Decision Report

NWTH Upgrades (Growth) – Biosolids Processing
and Construction Compound (August, 2024)

Figure 3-1 extract from NWTB community newsletter, June 2024

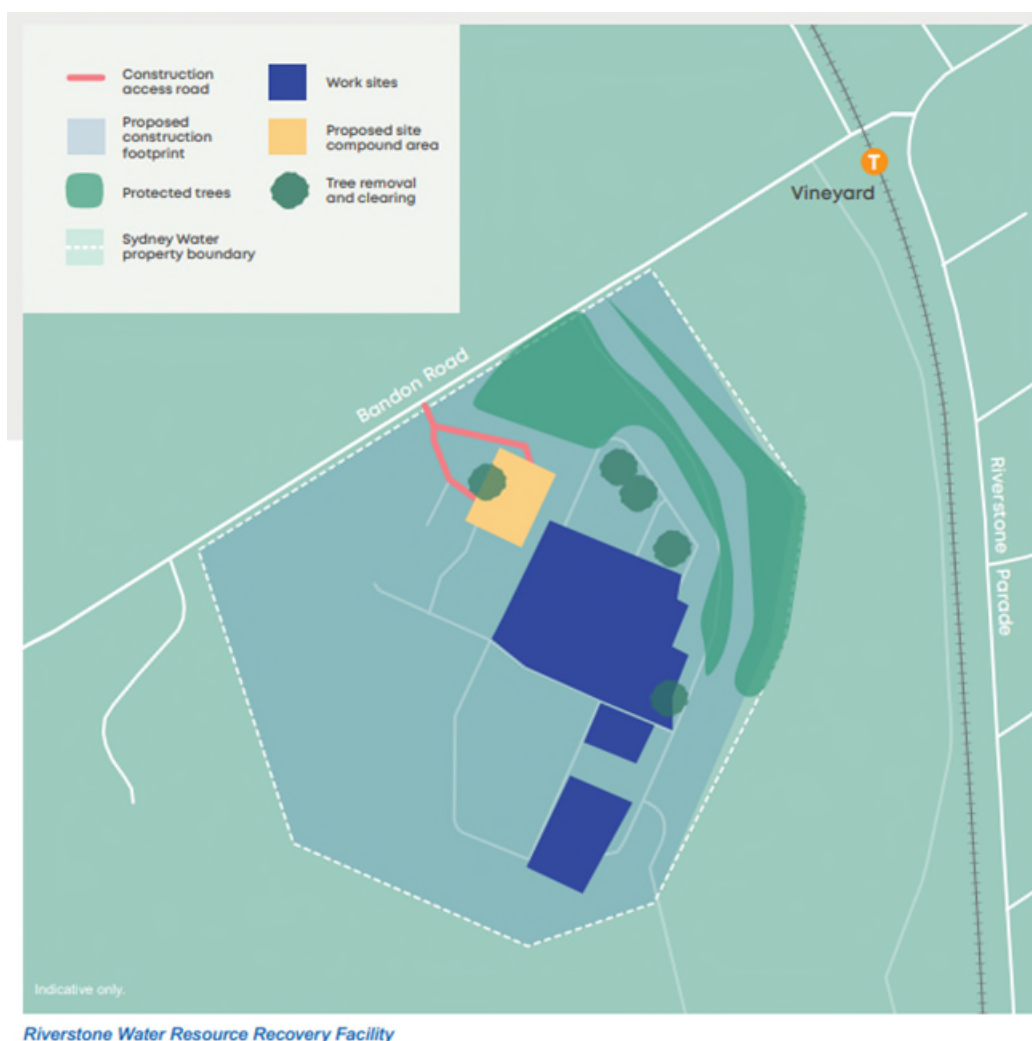
My only slight negative is the site diagrams in the leaflet are a little confusing as the construction footprint could imply you are building on the entire thing. In addition to the 'work site' labelling I presume that is existing? Better labelling or a hybrid overlay might be better.

This submission supports the proposed change; specifically, the carbonisation technology, avoiding building the sludge pipeline, increasing wastewater capacity and reducing odour and noise impacts. It also provides feedback that the community newsletter diagram was confusing (see Figure 3-1 below). The 'proposed construction footprint' label more correctly refers to the current operational area of the WRRF and the 'work sites' label refers to where construction will take place as part of this proposal. This feedback is useful and will be considered in the development of any future newsletters.
